File            SPR-1995-172  
 Date            10/599

Location: NE Corner of 28 Rd & Pattison Project Name: 19 1st Church of the Nazarenes

TITLE HEADING: Site Plan Review - 1st Church of the Nazarene

Nazarene Church Site Plan Review SPR-95-172  
Comments from Bill Nebeker  
October 5, 1995

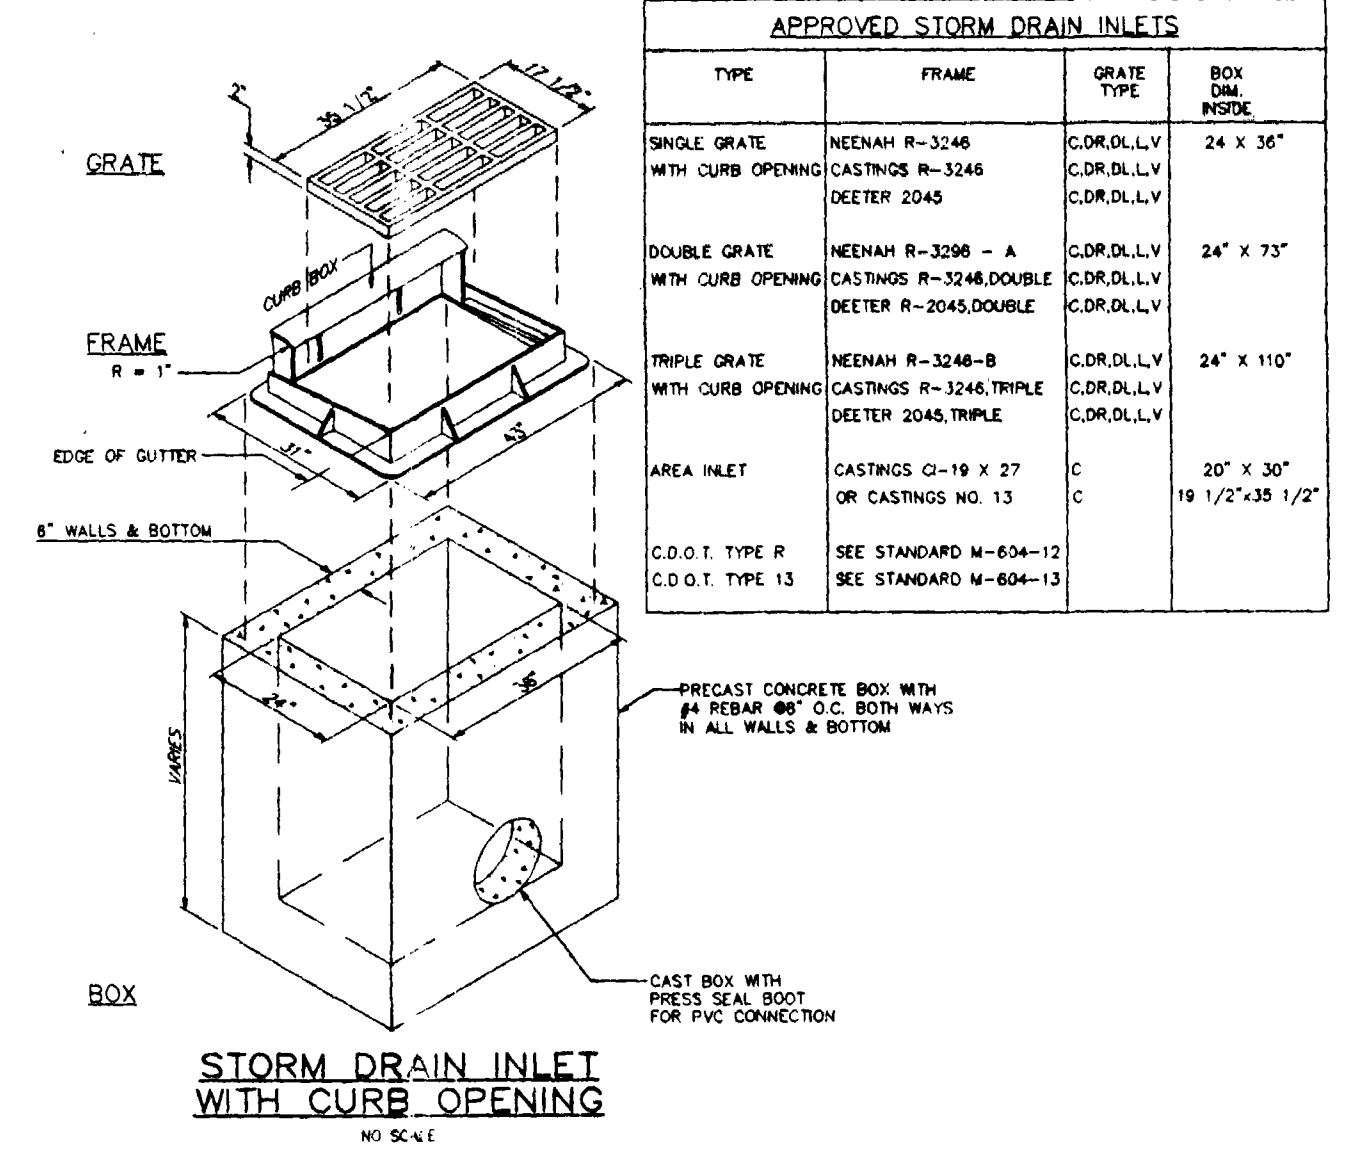
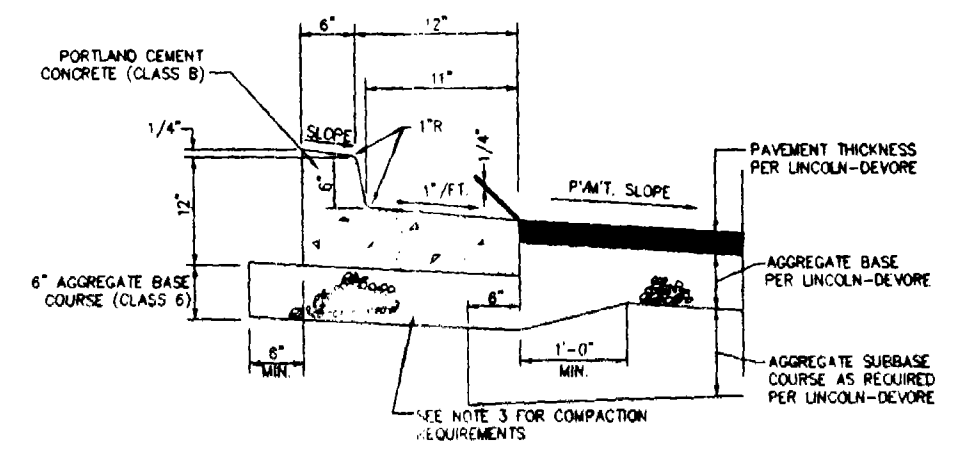
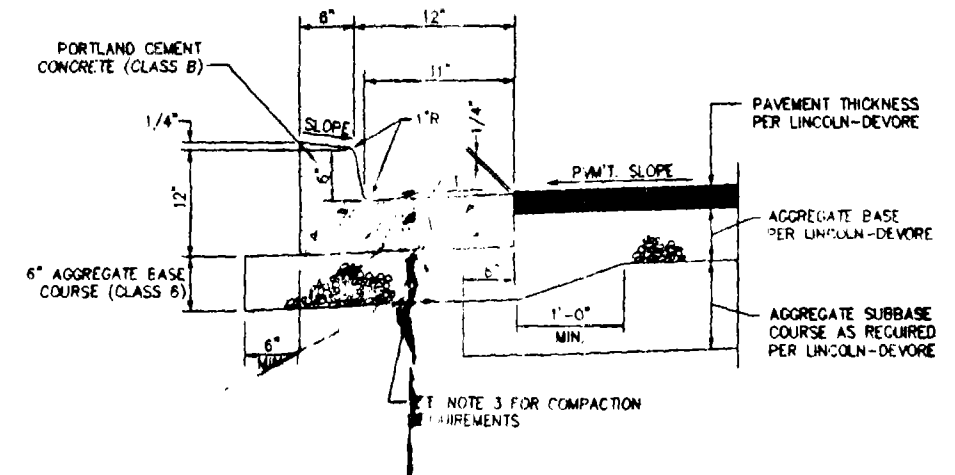
1. Typical parking dimension does not meet code. Minimum space length for 90 degree parking is 18.5 feet. Correct accordingly. (SECTION 5-5-1K).
2. Although not properly drawn, there is room for 5 accessible (handicapped) parking spaces in the location shown on the site plan. These spaces should be striped 8' wide X 18.5' length with an adjacent 5' wide aisle. Two spaces may share an aisle. One of the aisles must be 8' wide. One additional accessible space with a 5' wide aisle is needed. Please show these corrections on the site plan along with revised dimensions for the other 5 spaces. (See City of Grand Junction Engineering Division Exhibit "G" for details.)

1. Typical parking dimension does not meet code. Minimum space length for 90 degree parking is 18.5 feet. Correct accordingly. (SECTION 5-5-1K).

2. Although not properly drawn, there is room for 5 accessible (handicapped) parking spaces in the location shown on the site plan. These spaces should be striped 8' wide X 18.5' length with an adjacent 5' wide aisle. Two spaces may share an aisle. One of the aisles must be 8' wide. One additional accessible space with a 5' wide aisle is needed. Please show this location on the site plan along with revised dimensions for the other 5 spaces. (See City of Grand Junction Engineering Division Exhibit "G" for details.)

11/22/95 REV. PARKING DIMENSIONS  
REVISED 10/23/95: ADD LANDSCAPE CURBS & GRADES
